**NOTICE OF DETERMINATION
 PETITION TO MODIFY THE
 GENERAL PLANT ARRANGEMENT
 FOR THE MARIPOSA ENERGY PROJECT
 (09-AFC-4C)**

DOCKET	
09-AFC-4C	
DATE	SEP 19 2011
RECD.	SEP 19 2011

Mariposa Energy Project

FIGURE 2.3-1
GENERAL ARRANGE
Mariposa Energy Project
Alameda County, California

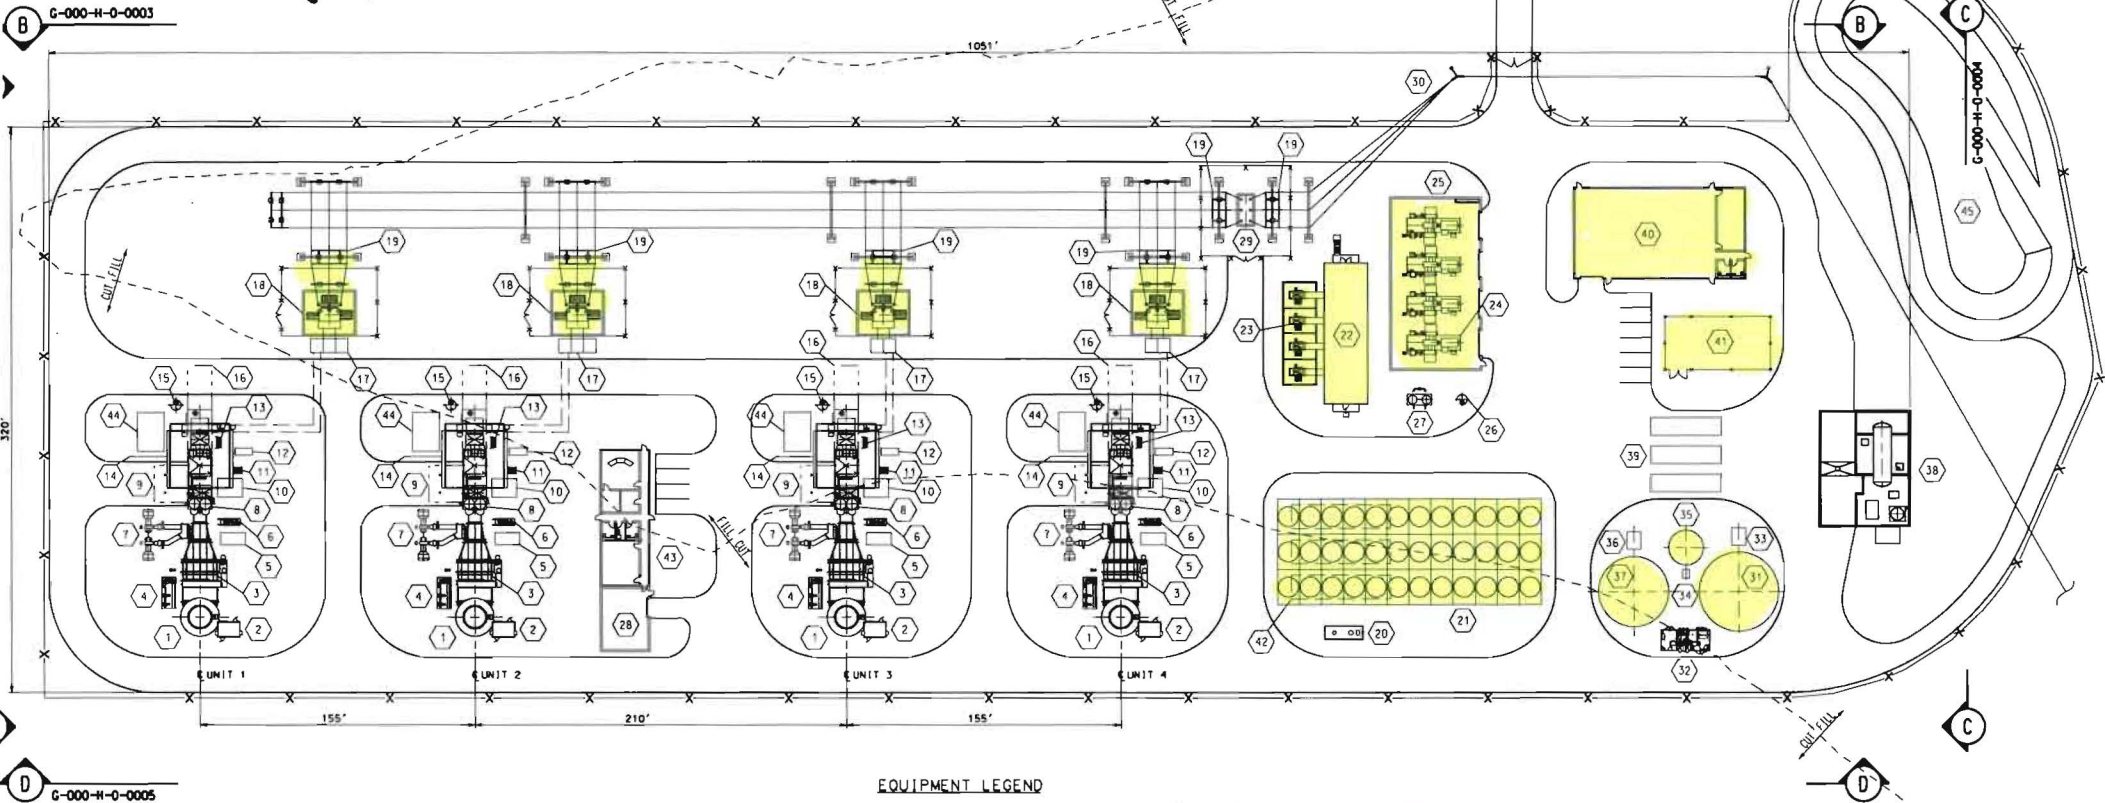
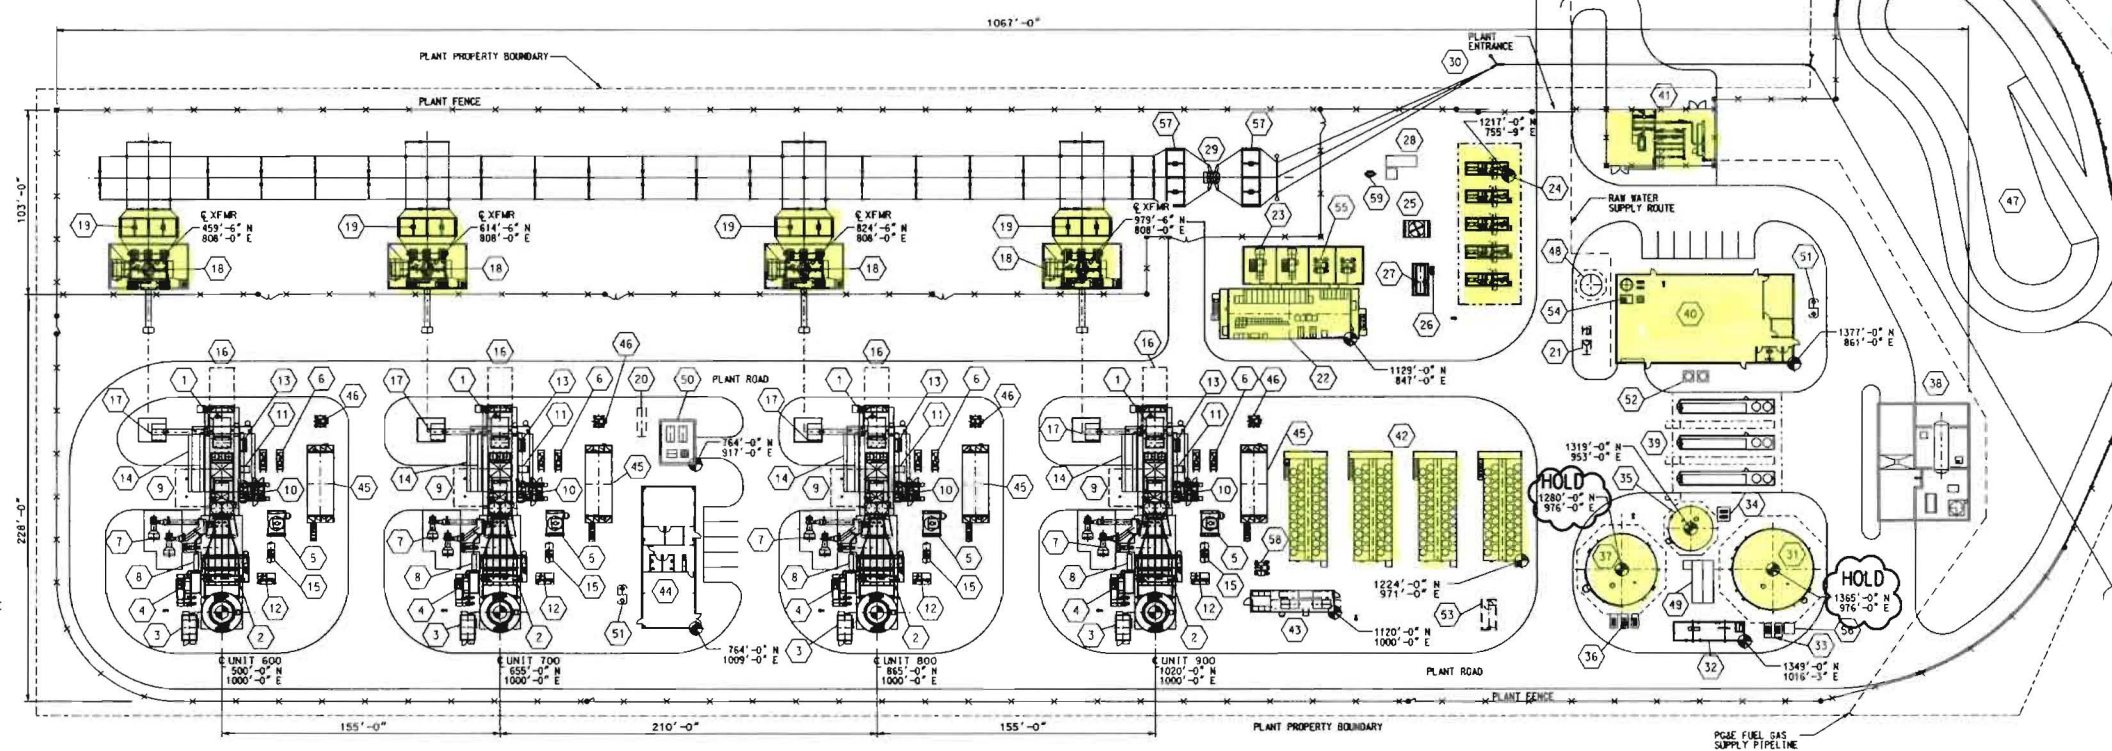
During the final design phase of MEP, Mariposa Energy's engineering contractor determined that the general arrangement drawing included in the Application for Certification (AFC) (Figure 2.3-1) required minor revisions, including the slight shifting of the location of the water storage tanks near the firewater pump, and minor adjustments to the location, orientation, and configuration of certain other structures and equipment. The original site layout and proposed site layout is attached.

Mariposa Energy is proposing to move the water tanks, and relocate several buildings and ancillary equipment, there are no proposed changes to the location of the combustion turbine exhaust or the firewater pump exhaust stacks identified in the Final Decision. The following is a list of the minor revisions to the locations of the buildings and equipment compared to the general arrangement equipment layout used during the licensing proceeding and the air dispersion modeling analysis used as the basis for the Commission Decision.

- The wastewater tank move approximately 22 feet southwest.
- The demineralized water tank move approximately 31 feet southwest.
- The raw water tank move approximately 11 feet southwest.
- The fuel gas compressor skids will move approximately 30 feet northwest.
- The Warehouse and Maintenance Building move approximately 50 feet southeast.
- The gas metering station move approximately 80 feet west.
- The 230-kilovolt (kV) circuit breakers, 230-kV disconnect switch, and the generator stepup transformers will each move approximately 20 to 120 feet southwest, respectively.
- Orientation of the power distribution center, auxiliary transformers, and station transformers are rotated 90 degrees counter clockwise.
- The single-unit chiller package will be replaced with a four-unit chiller package. The chiller package will move approximately 43 feet southwest. The original chiller module

arrangement depicted on the general arrangement was based on one of multiple potential manufacturers. Chiller module sizes and arrangements vary among potential suppliers, and the current arrangement was not known until final vendor selection was completed. During final bidding, the vendor retracted the design offer originally shown, and the four-unit chiller package shown is the final design selected for the project.

Air Quality - The project's new general arrangement would not affect the building downwash parameters for any of the four combustion turbines but would affect the downwash characteristics of the fire pump engine. Based on the results of the BPIP analysis and the updated AERMOD version analysis, it is concluded that the turbine commissioning impacts will not be affected by the proposed general arrangement revision. There are no proposed changes to the permitted turbine and fire pump stack locations. The project will comply with all applicable ambient air quality standards and will not result in any significant air quality impacts.

Noise and Vibration - The chiller package represents one of the noise sources associated with the licensed project. However, the noise from the project, as modified, will remain below all applicable noise standards and the selection of an alternate chiller package does not require a modification to the Conditions of Certification for noise. Therefore, the facility will continue to meet all existing environmental standards and there will be no significant adverse environmental impacts.
